| | Po Appropriate Bistrice | 39 PM | State of New Me | xico | | Form C-103 | |
|---|---|-----------------------|---|-----------------------|-----------------------------|-----------------------------------|--|
| SUNDRY NOTICES AND REPORTS ON W (DO NOT USE THIS FORM FOR PROPOSALS TO DRILL OR TO DEEPEN | | | | | | ame or Unit Agreement Name | |
| DIFFERENT R | RESERVOIR. USE "AP | | | (FORM C-101) FOR SUCH | | Zeus SWD | |

Re: Workover NOI

Zeus SWD #1 30-025-44273

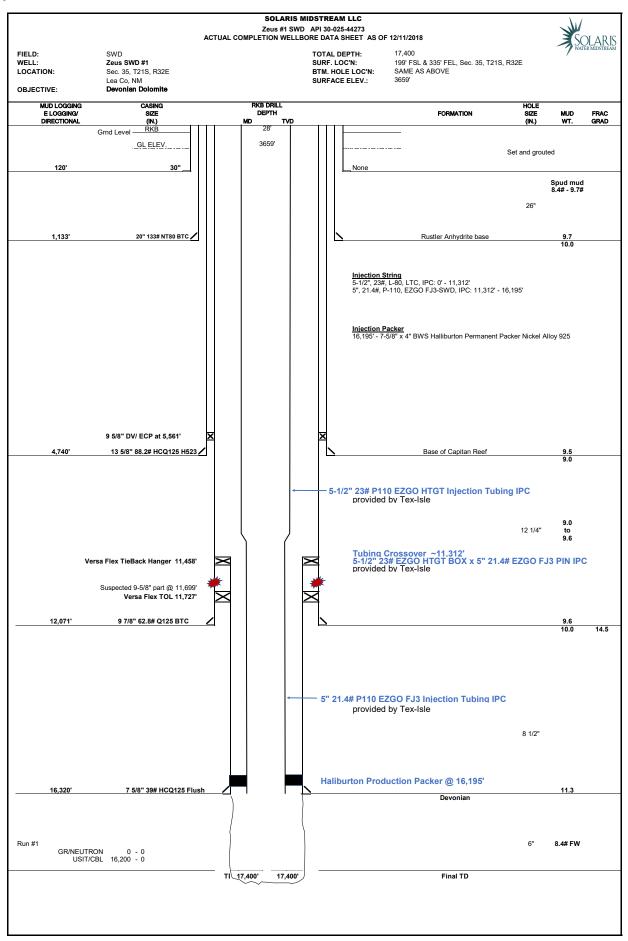
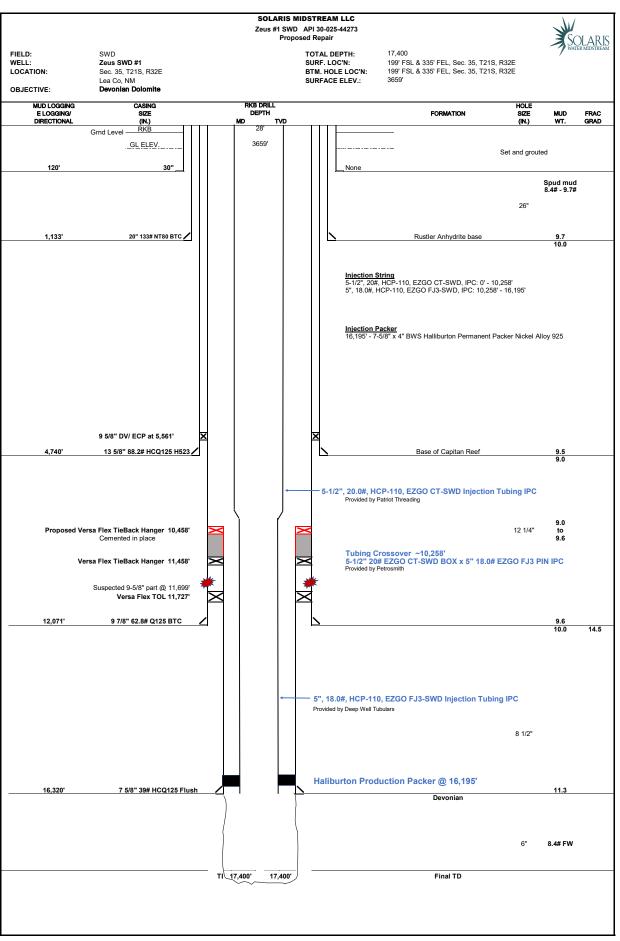
| Created By | Condition | Condition Date |
|---------------|---|-------------------|
| mgebremichael | Should tubing replacement be required, the same tube size shall be replaced as prescribed by the respective order. And, the packer shall be set not more than 100 ft. above the top of the perforation or top part of the injection interval. | 3/14/2024 |
